**MASON COUNTY PUBLIC SERVICE DISTRICT
MASON COUNTY, WEST VIRGINIA**

CONTRACT #2 - J2Y35 WATER TANK REPLACEMENT

ADDENDUM #2

THRASHER PROJECT #010-10151

SHEET No.
5

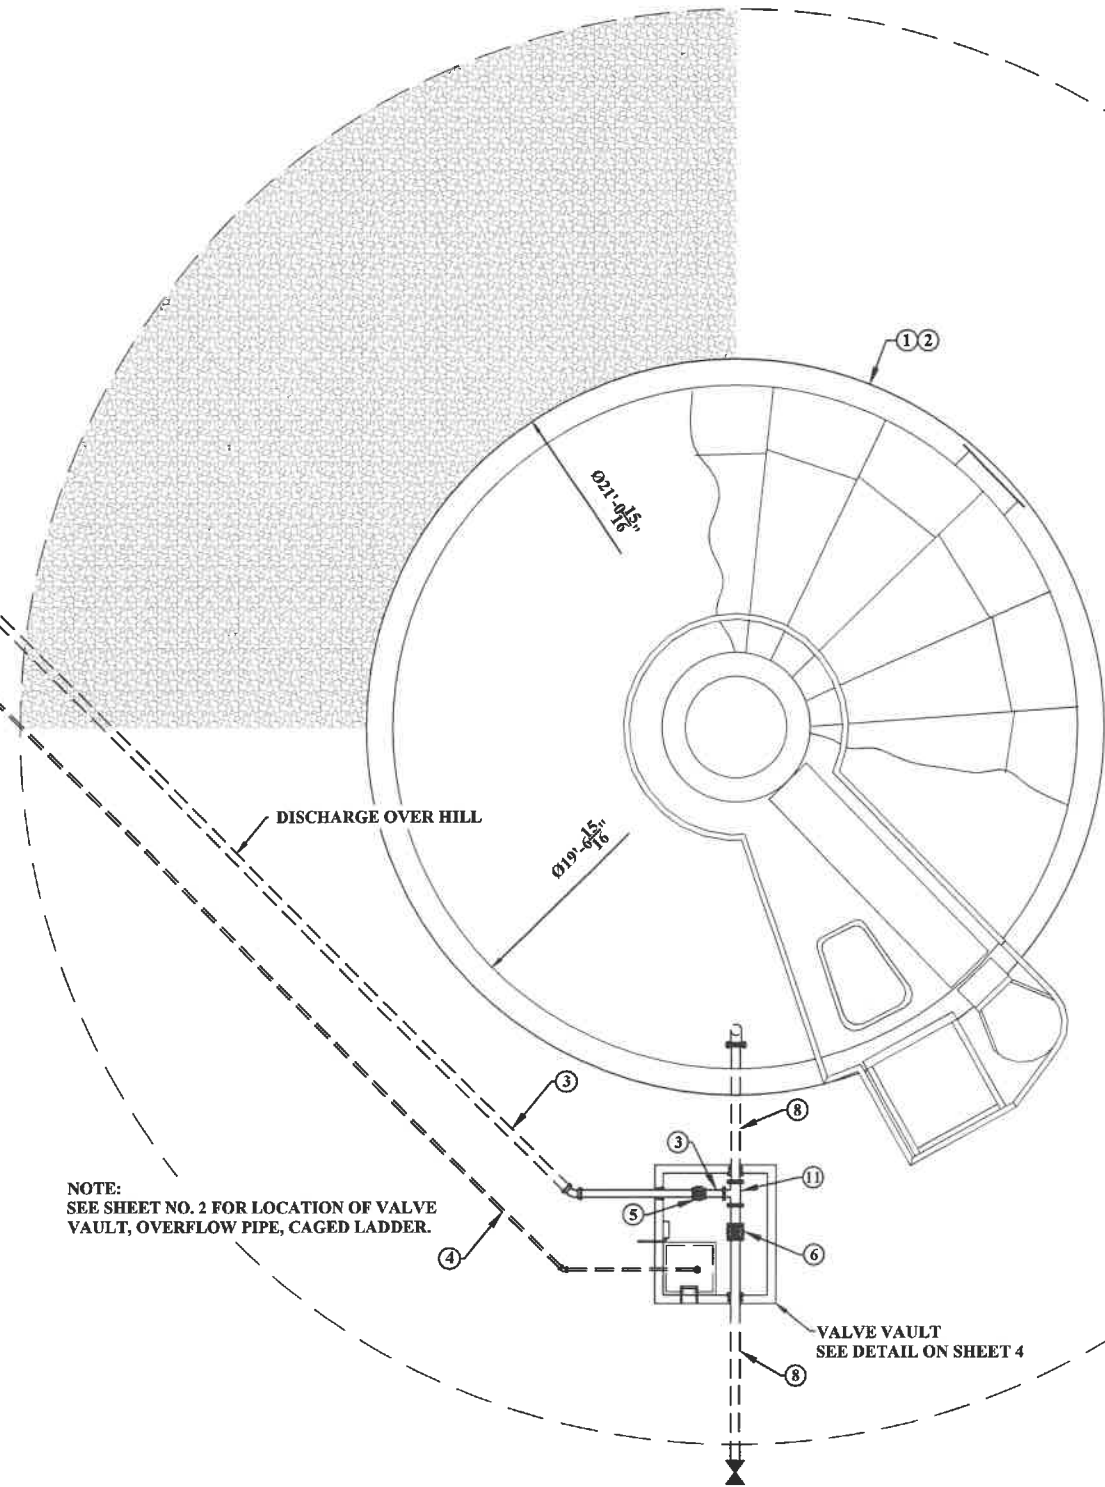
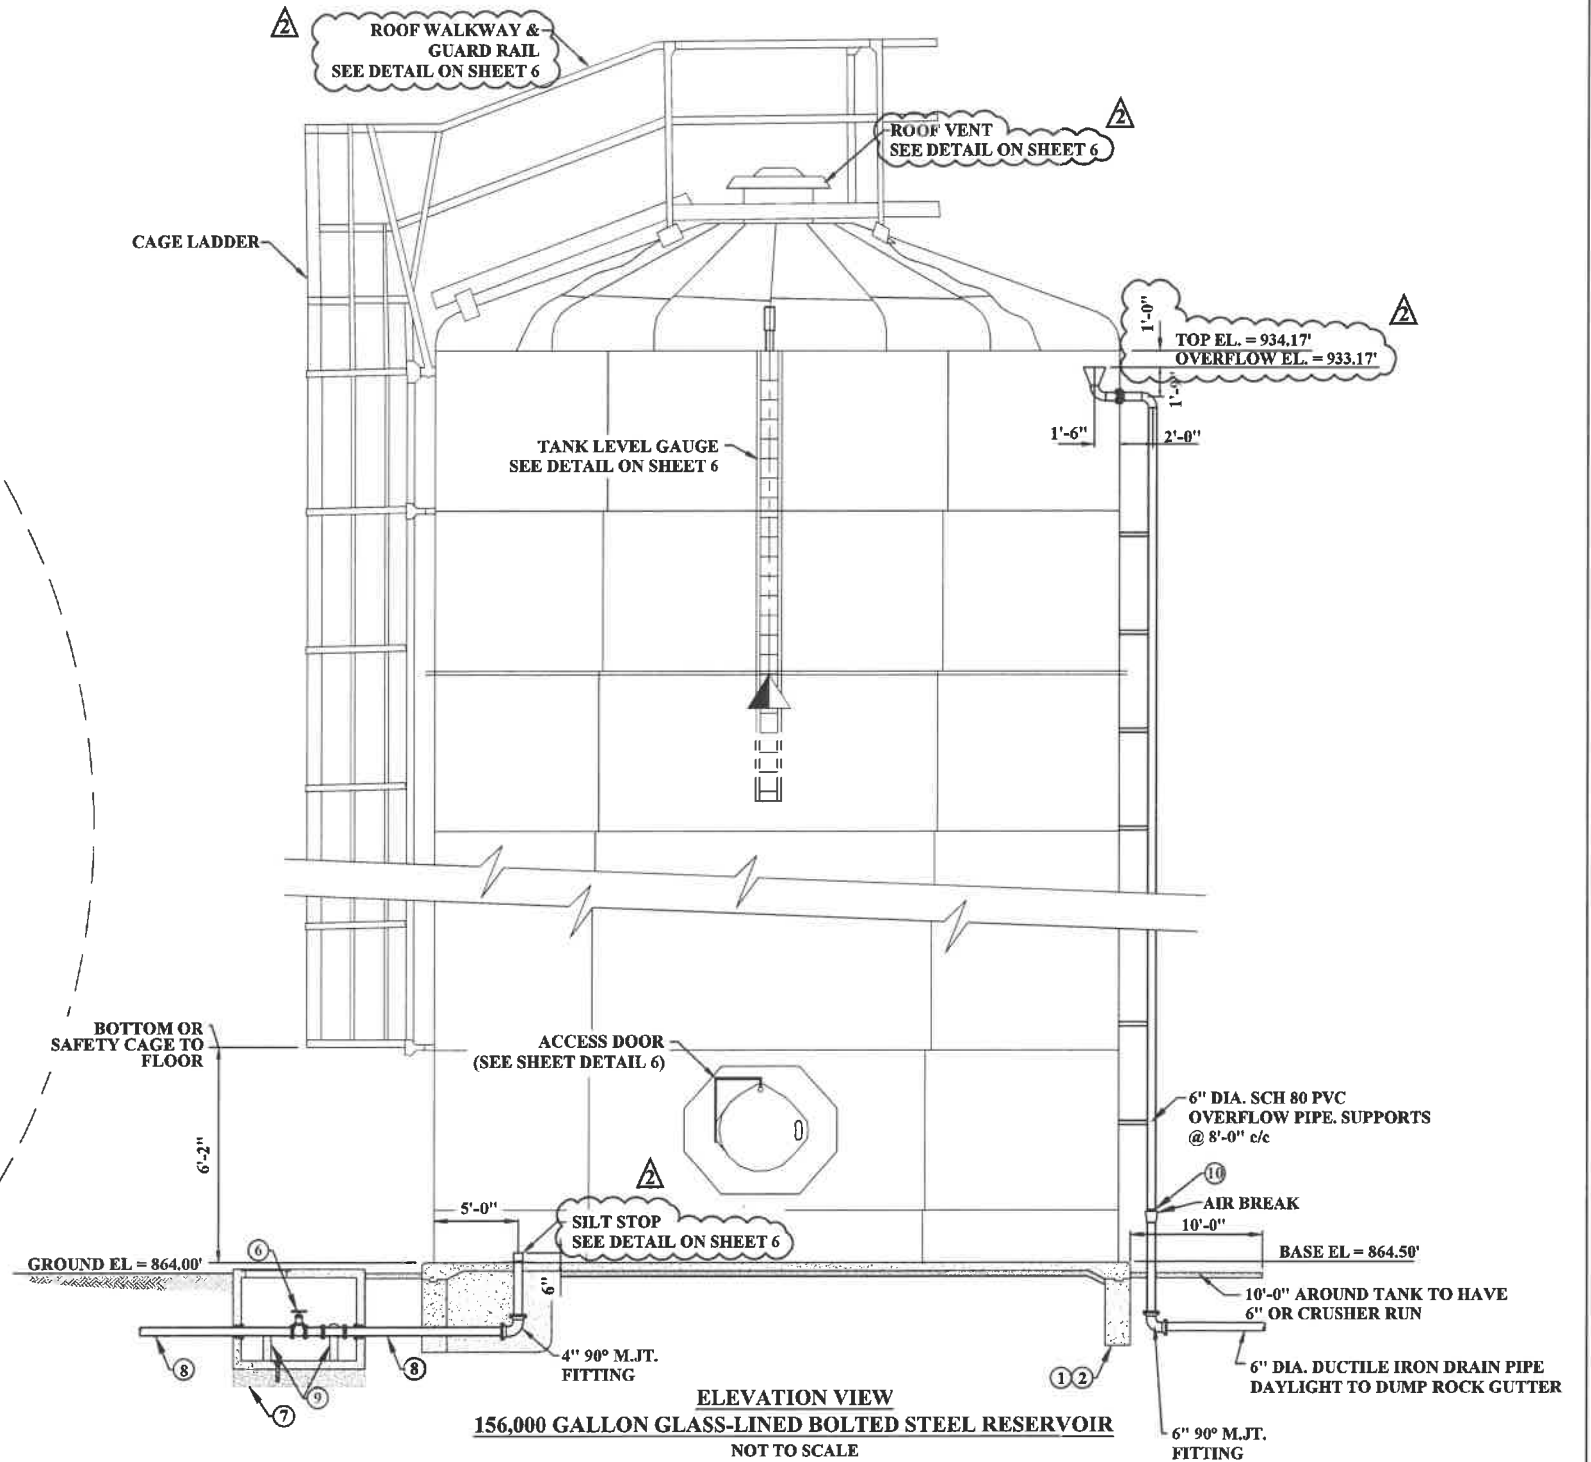
2. What is the Freeboard amount required for the tank?

NO.	BY	DATE	DESCRIPTION
2	KMP	11/2022	ADDENDUM #2 - UPDATED ELEV. & SHEET NUMBERS ON NOTES

Twelve inches. Refer to Sheet 3 and Sheet 5 included in this Addendum #2.

SILT STOP DETAIL FOR GLASS-LINED TANK
NOT TO SCALE

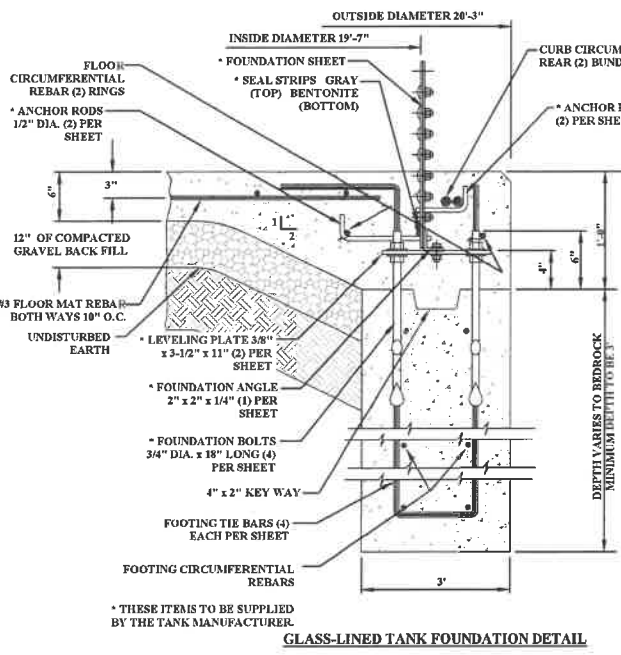
3. Can you provide a Silt Stop Detail for a Glass-Fused-to-Steel Tank?

Yes, Refer to Sheet 6 included with this Addendum #2.

SHEET No.
9

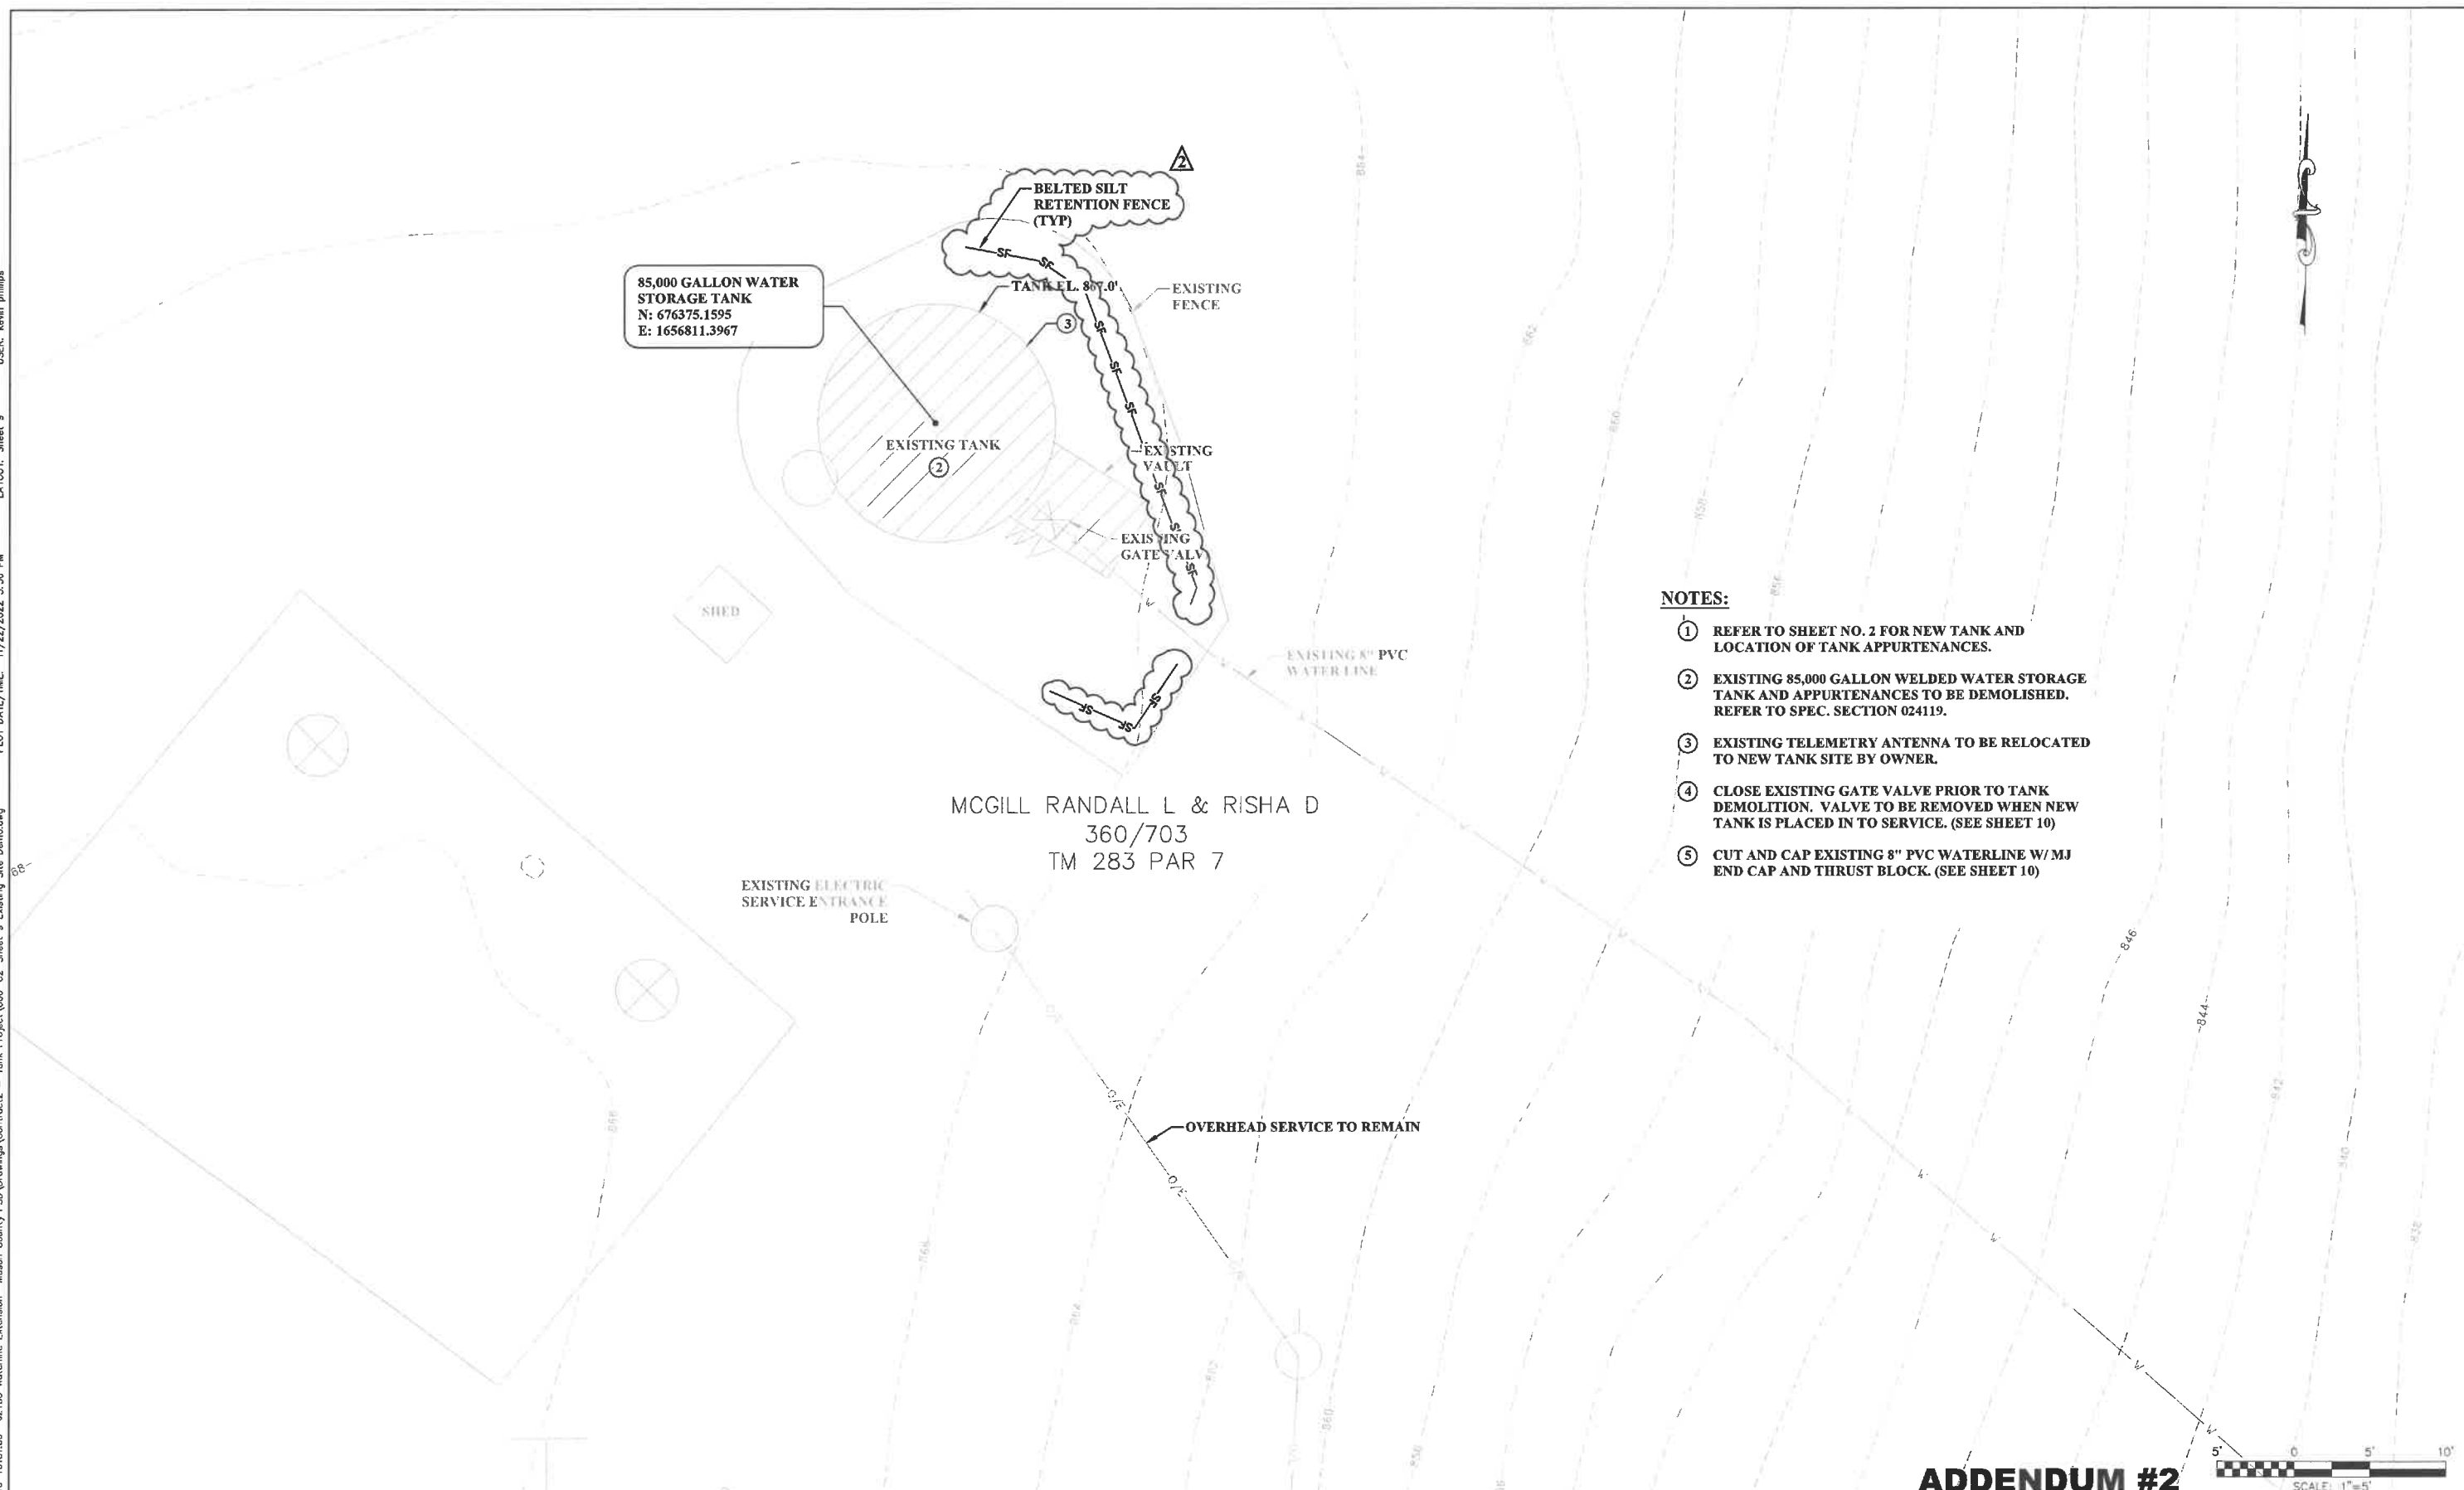
1. Erosion and Sedimentation Controls have been included on Sheets 2 and 9 included with this Addendum #2.

NO.	BY	DATE	DESCRIPTION
2	KMP	11/2022	ADDENDUM #2 -- ADDED BELTED SILT RETENTION FENCE
